5R110W Remanufactured Valve Body

F05R110

5R110W Pressure Switches Notice

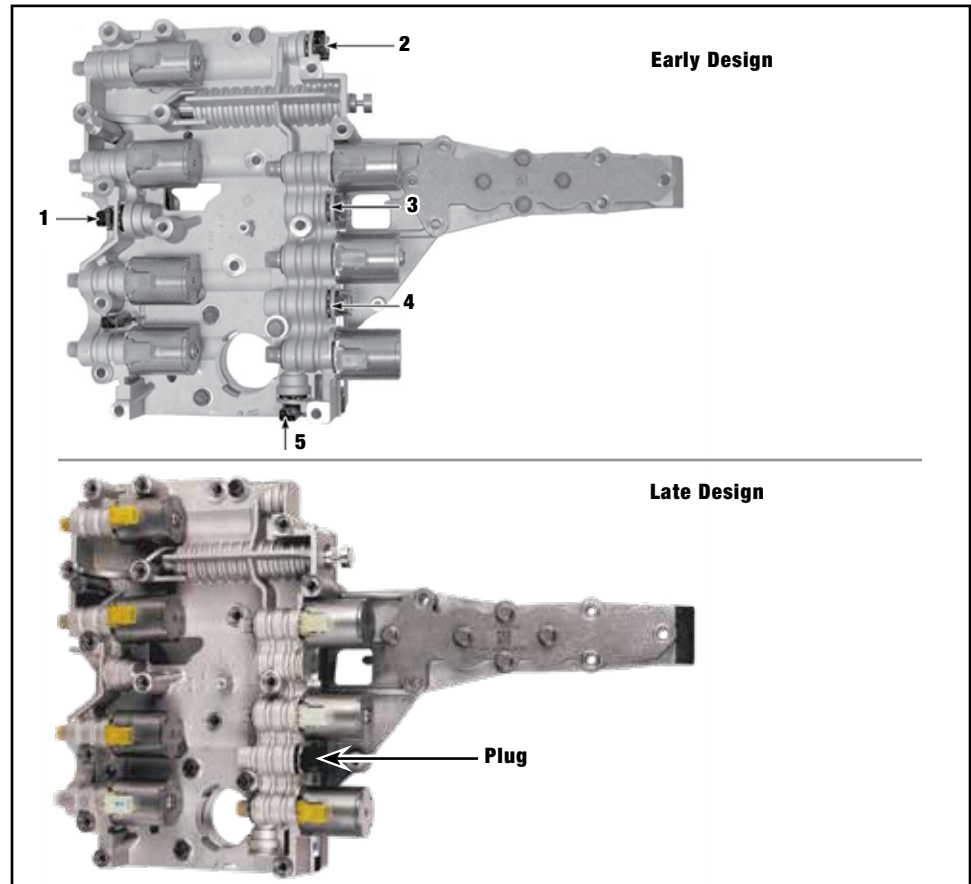
5R110W solenoid body **F05R110** is serviced without any pressure switches. Your original solenoid body may have one or five pressure switches depending on model year. The computer on these vehicles was never programmed to monitor the pressure switches and Ford removed them in late 2004. The later solenoid body may have one pressure switch with no wire going to it. In this application it is only used as a plug with the remaining four holes cast over.

Our remanufactured solenoid body is a late design with a plug installed instead of the one pressure switch. It will work perfectly fine in early one or five pressure switch applications. Simply leave the wiring for the pressure switches in position and not connected.

See Ford Special Service Message 17614 for more detailed information. See arrows above for locations of pressure switches on a five pressure switch version.

If you prefer to replace the harness both Ford and the aftermarket service the replacement harness without the wiring or connectors for the switches.
